ROTHER DEVELOPMENT AND SITE ALLOCATIONS LOCAL PLAN

SCHEDULE OF MAIN MODIFICATIONS AND CHANGES TO POLICIES MAPS

July 2019

Modified Policies Map 2 | Policies Map Inset Map 6: Broad Oak [MM21] [PMM3]

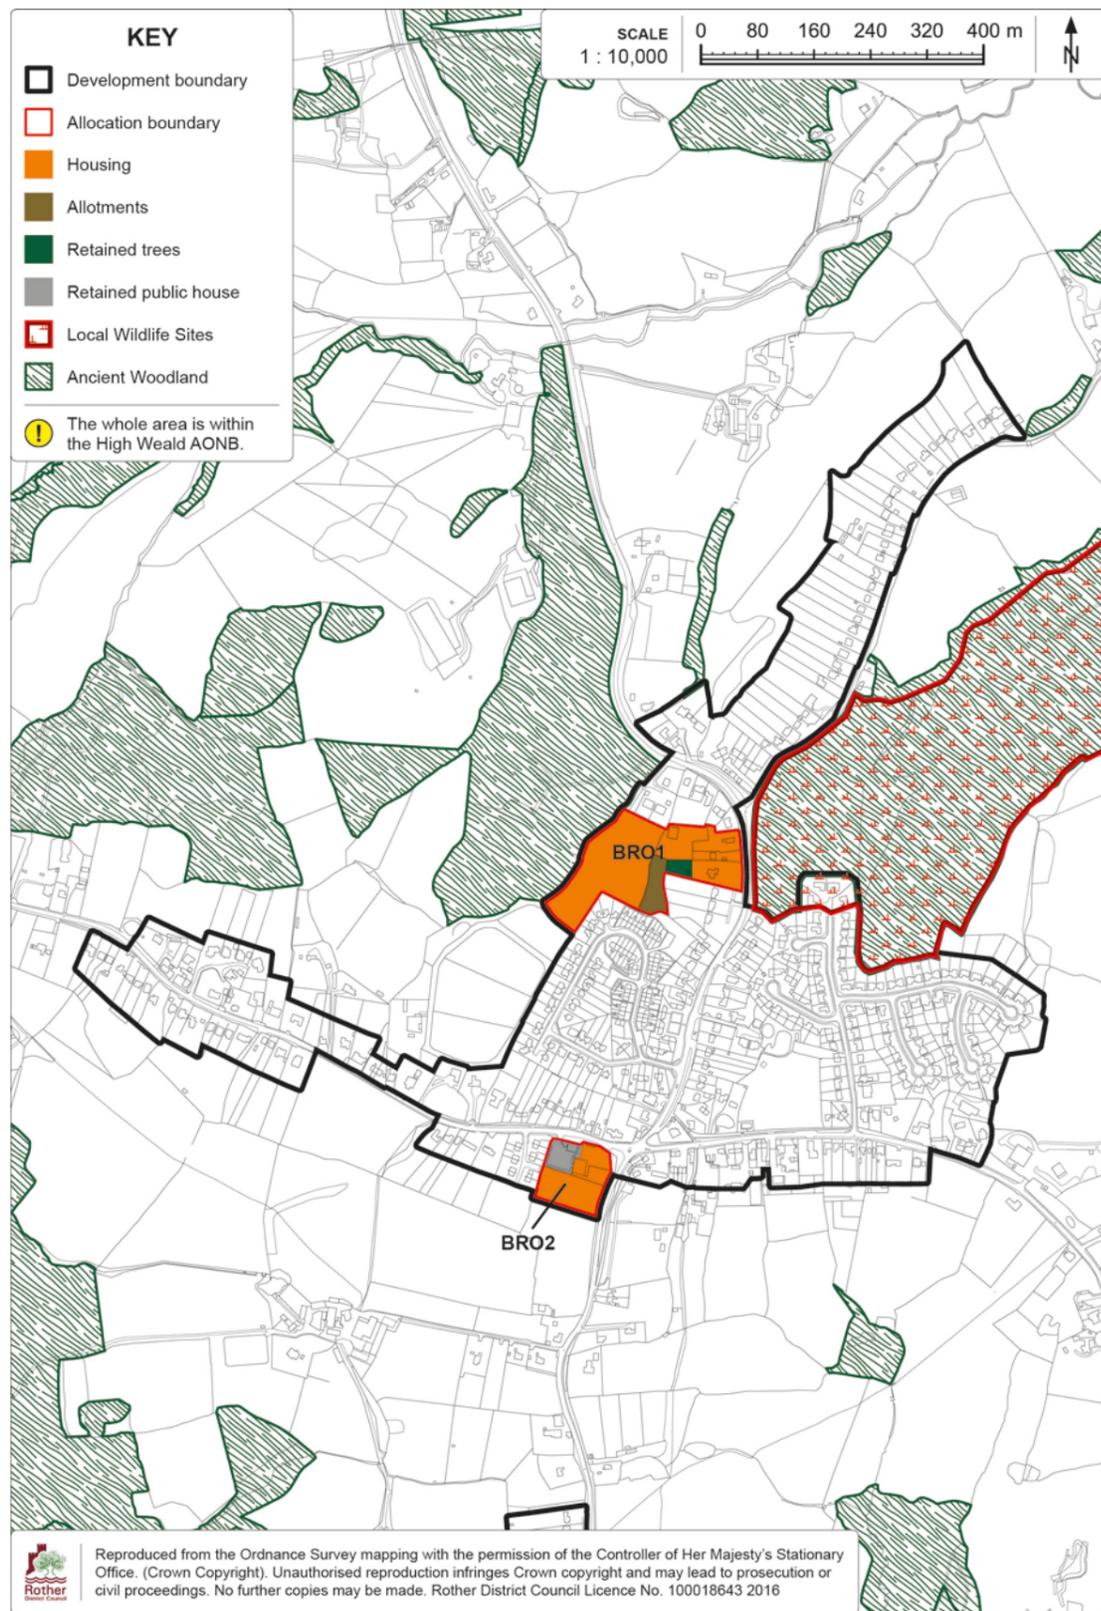
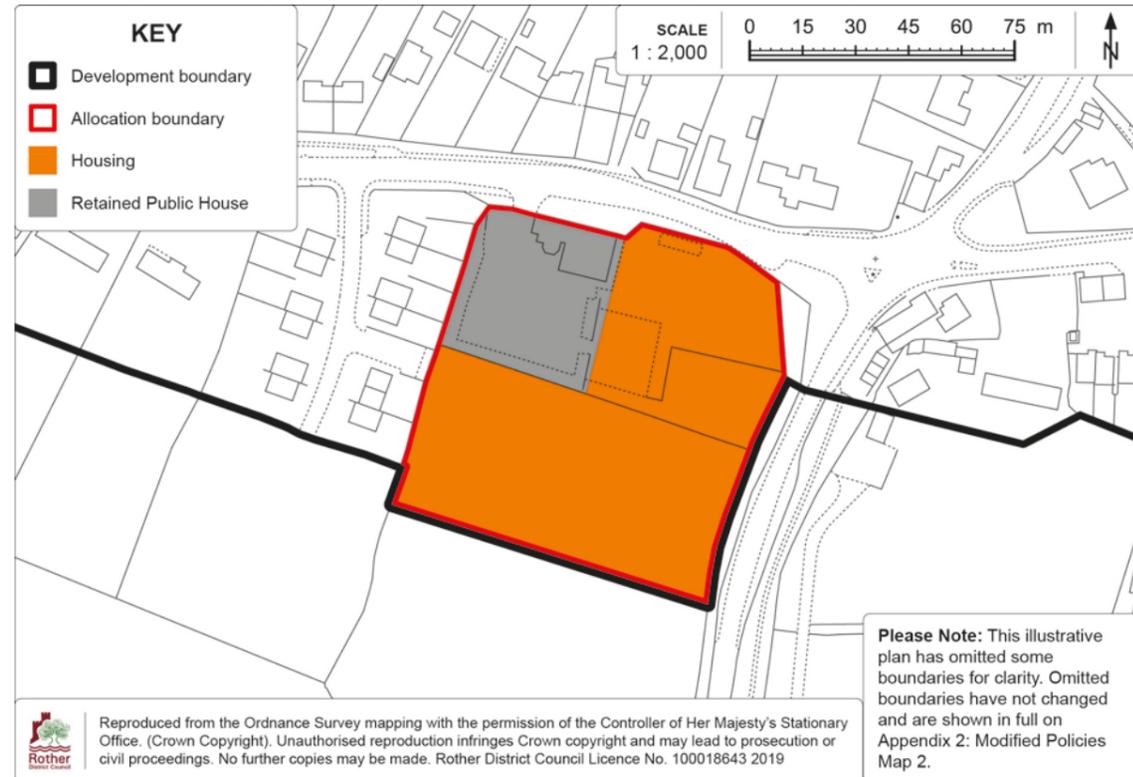
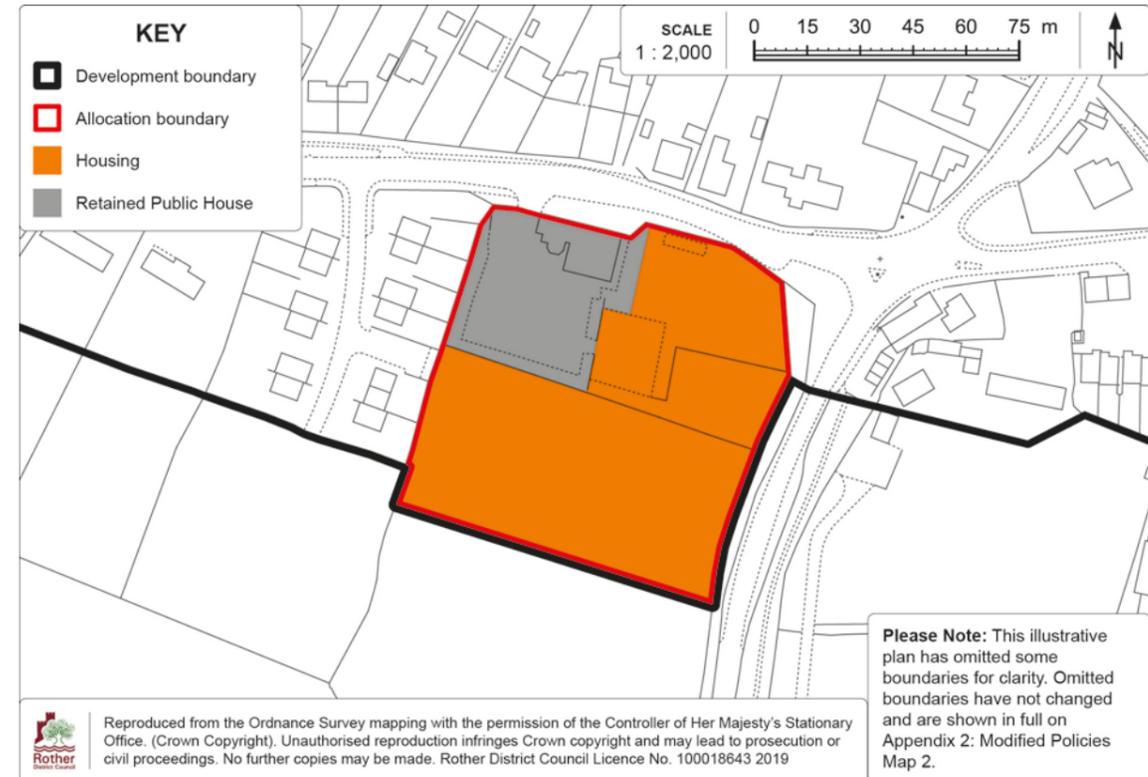
Policy BRO2 (v)	Insert an additional policy criterion after (v): <i>(vi) provision is made for an acceptable connection to the local sewerage system, in agreement with the service provider.</i>	
		Figure 45: Policy BRO2 Detail Map	Policy BRO2: Land at the Rainbow Trout public house: It is necessary to make a slight amendment to the extent of the proposed housing area shown on the Detail Map to accord with the details of the planning application (reference RR/2018/1813/P) which was delegated to approve, subject to the completion of a Section 106 Legal Agreement, on 12 th February 2019. Amend the western boundary of the northern section of the housing area (shown in orange) on Figure 45 (Policy BRO2 Detail Map) by a marginal amount to accord with drawing no. 1802-P-204_B, submitted pursuant to planning application RR/2018/1813/P. <u>Please see Appendix 1: Modified Detail Map 3</u> Policies Map Inset Map 6: Broad Oak has also been updated in this regard. <u>Please see Appendix 2: Modified Policies Map 2 for the amended Policy Map Inset Map.</u>

Modified Policies Map 3 | Policies Map Inset Map 9: Fairlight Cove [MM7] [PMM4] [PMM5]

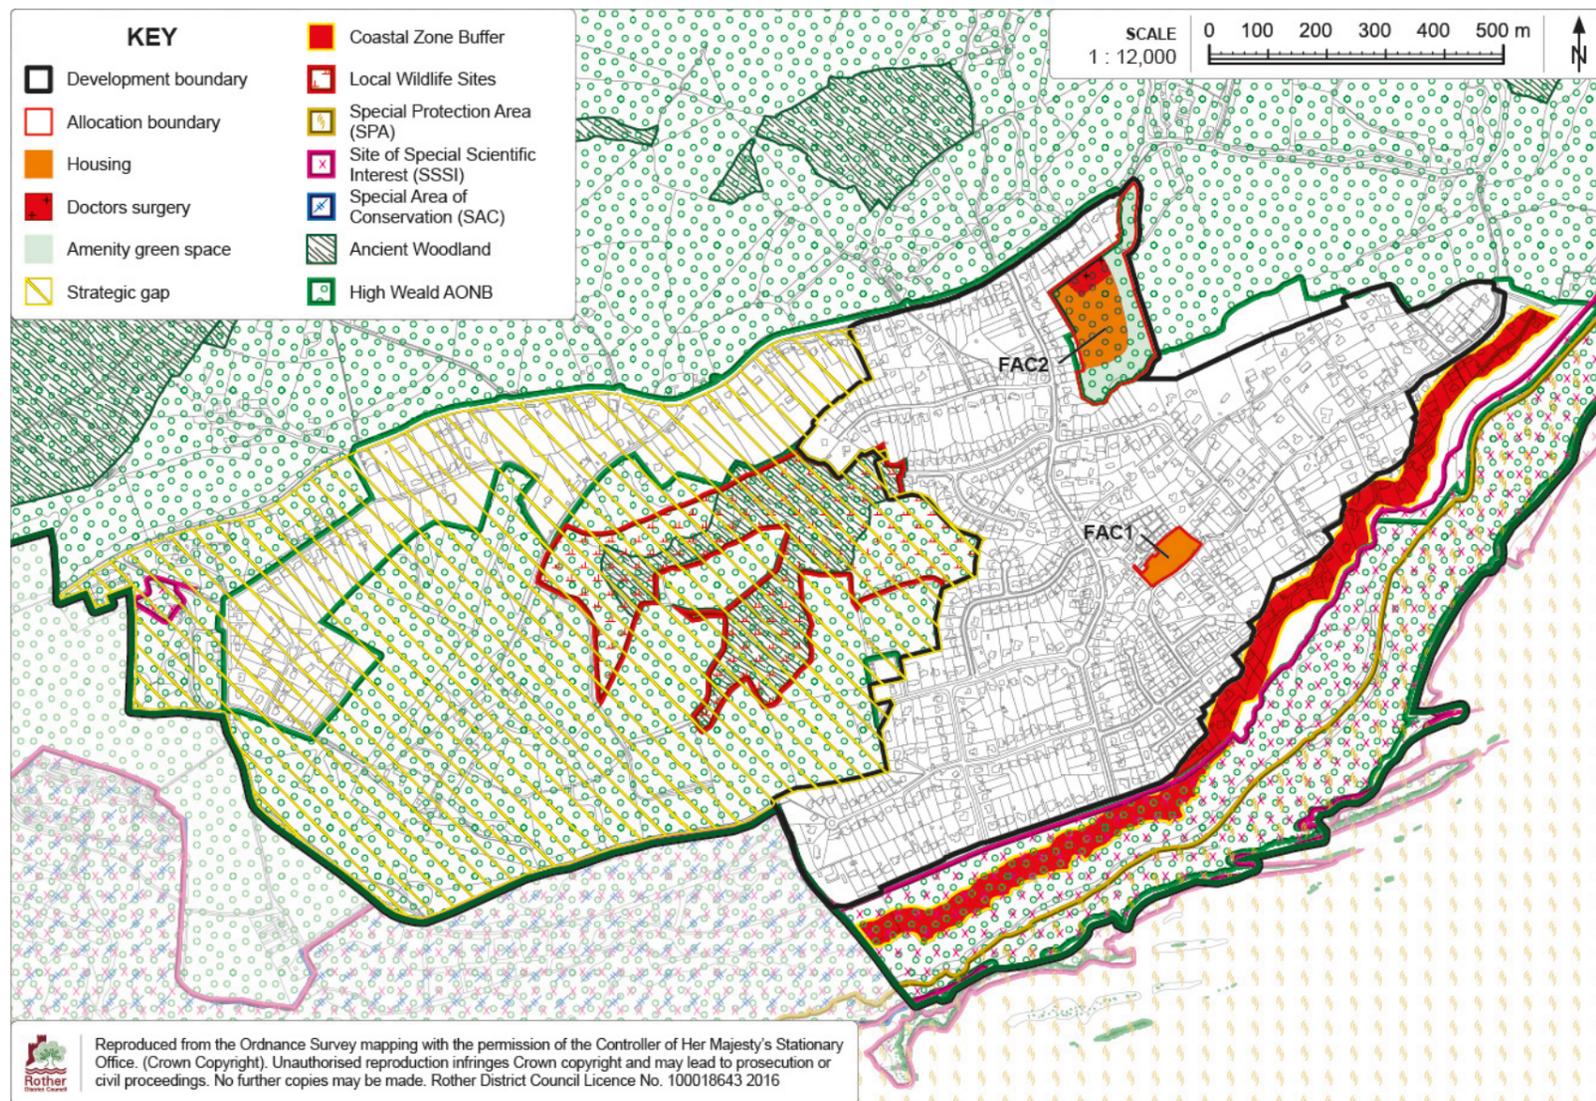
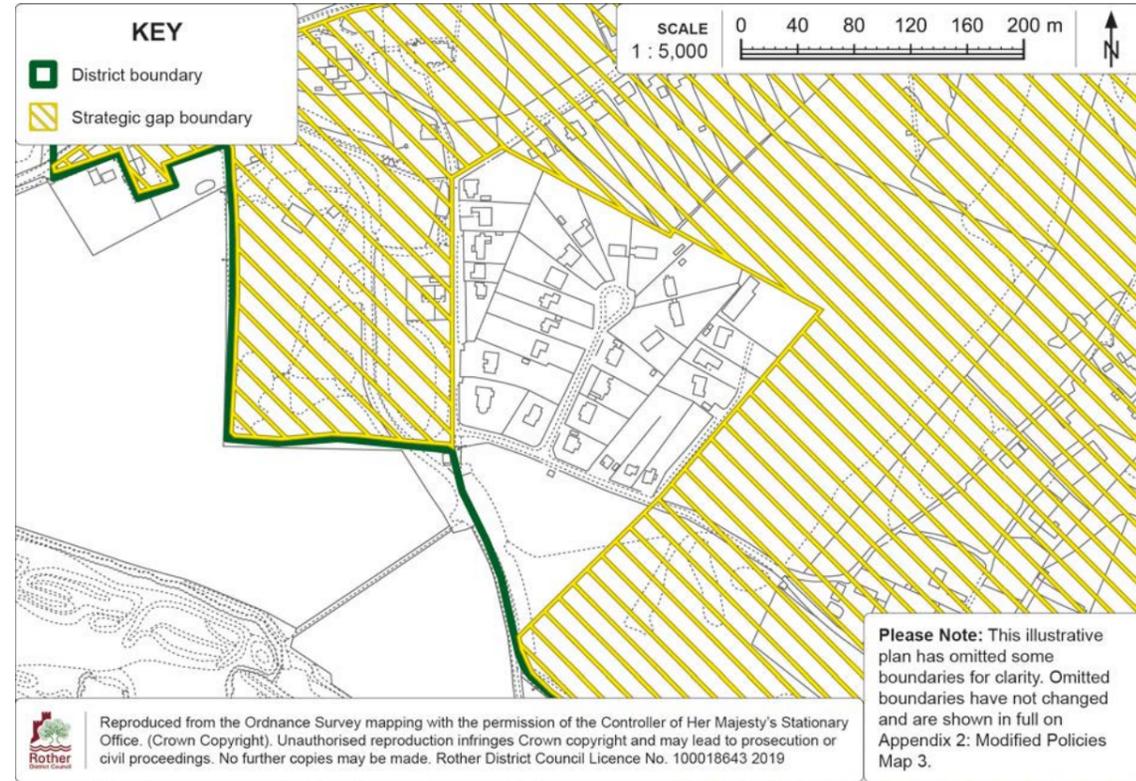
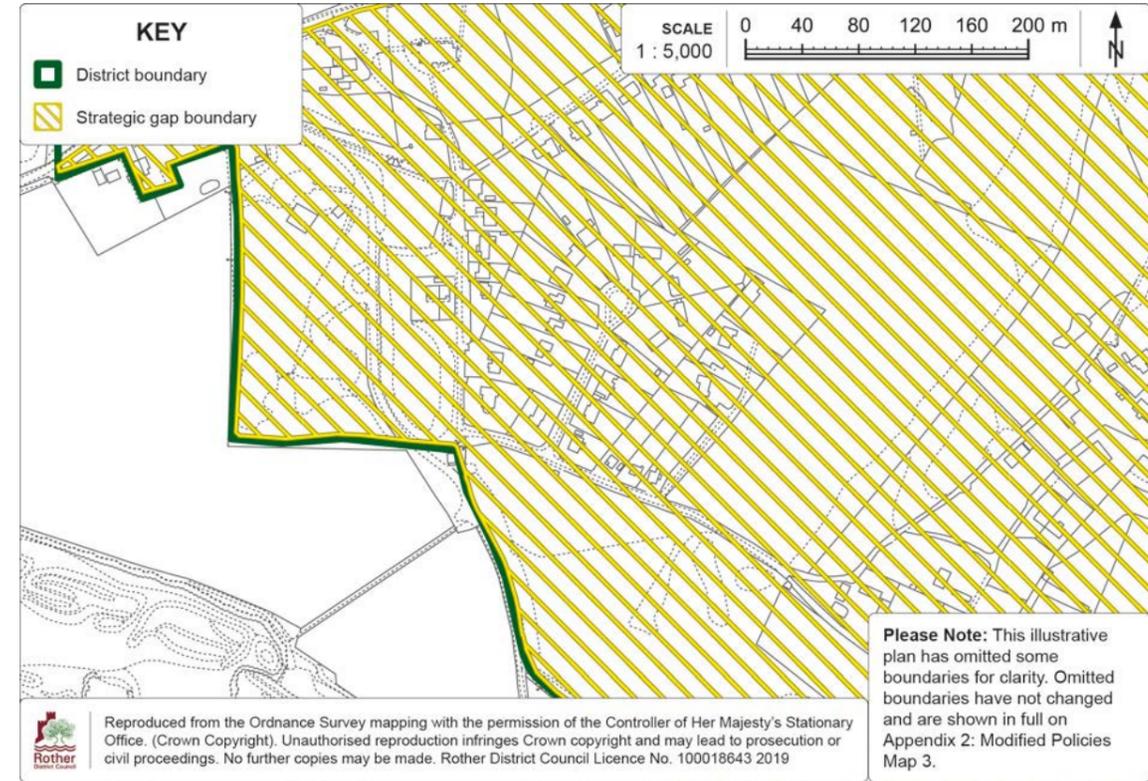
PMM4	226	Policies Map Inset Map 9: Fairlight Cove	Amend Policies Map Inset Map 9 to reflect the amendment made to Figure 7: Strategic Gap at Fairlight to include The Close, as described in paragraph 6.21. <u>Please see Appendix 2: Modified Policies Map 3 for the amended Policy Map Inset Map.</u>	Cartographical error – To make consistent with the supporting text at paragraph 6.21 which refers to The Close being included within the Gap.
PMM5	226	Policies Map Inset Map 9: Fairlight Cove	In line with the modification to Figure 50: Policy FAC2 Detail Map, modify Policies Map Inset Map 9 so that the size of the site area for FAC2 includes a greater amount of land along the proposed access. Move the boundary to the east of the proposed access approximately 10m further east and move the development boundary to be in line with this. <u>Please see Appendix 2: Modified Policies Map 3 for the amended Policy Map Inset Map.</u>	To ensure that the site access is of an adequate size to accommodate a sufficient alignment together with acceptable visibility splays.

Modified Policies Map 4 | Policies Map Inset Map 14: Westfield [MM30] [PMM6]

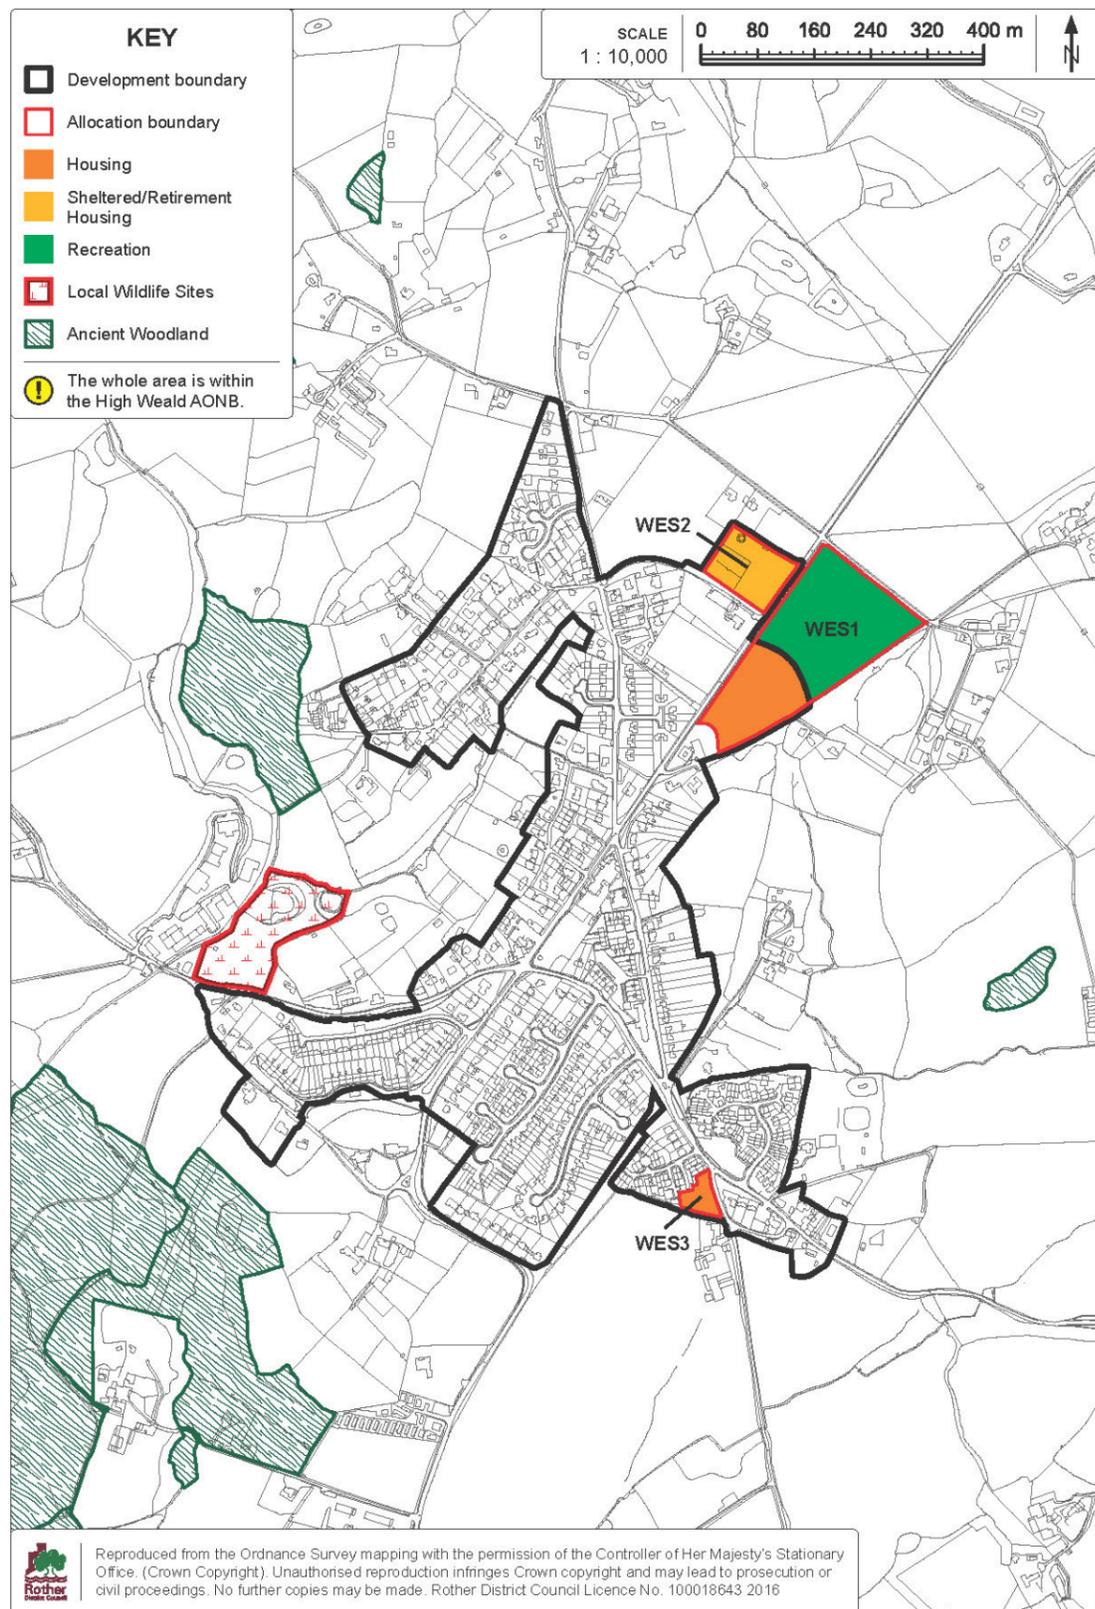
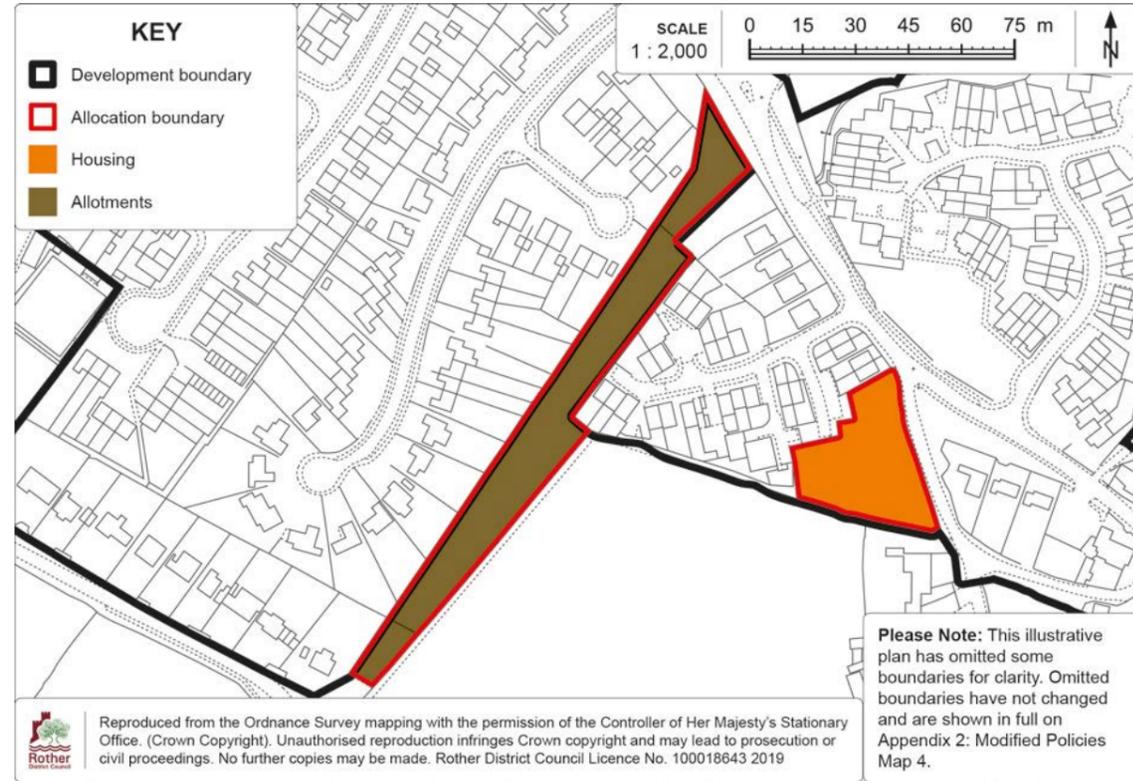
PMM6	260	Policies Map Inset Map 14: Westfield	Amend Policies Map Inset Map 14: Westfield (page 260) to delete the text and image indicating Policy WES4 and also the "Allotments" notation in the Key. <u>Please see Appendix 2: Modified Policies Map 4 for the amended Policies Map Inset Map.</u>	Policy WES4 deleted as the land owner has indicated that the land is no longer available for the use proposed.

11.236-11.239	Delete paragraphs 11.236 to 11.239 inclusive and amend the numbering of subsequent paragraphs accordingly.	
		Policy WES4	Delete Policy WES4 (yellow box) on page 259	
		Figure 60: Policy WES4 Detail Map	Delete Figure 60: Policy WES4 Detail Map	
		Policies Map Inset Map 14: Westfield	Amend Policies Map Inset Map 14: Westfield (page 260) to delete the text and image indicating Policy WES4 and also the "Allotments" notation in the Key. <u>Please see Appendix 2: Modified Policies Map 4 for the amended Policies Map Inset Map.</u>	
MM31	Appendix 1 amended to include a list of Core Strategy policies which have been superseded by their respective DaSA policies.	Table of Contents	In 'Table of Contents', under Appendix 1 add: <u>Superseded Core Strategy Policies</u>	To ensure that it is clear which DaSA policies supersede the Core Strategy policies. See below. Similarly, Appendix 2 sets out which DaSA policies supersede the Local Plan 2006 policies. Providing this additional appendix will ensure that it is clear which policies no longer form part of the development plan.
